## SERVICE BULLETIN

REFERENCE BODY  
NUMBER 020  
DATE 06-17-88  
MODEL 4RUNNER

### BACK DOOR LOCK CYLINDER (4RUNNER)

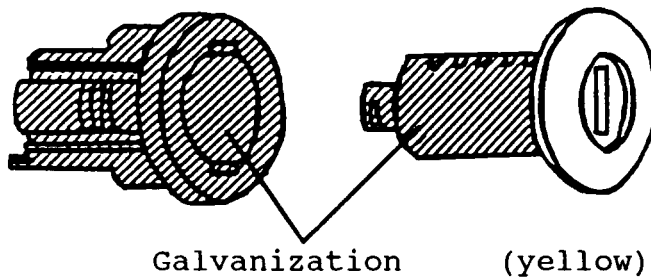
To improve the corrosion resistance of the lock cylinder, galvanization has been applied to the lock cylinder and cylinder case surface as shown below:
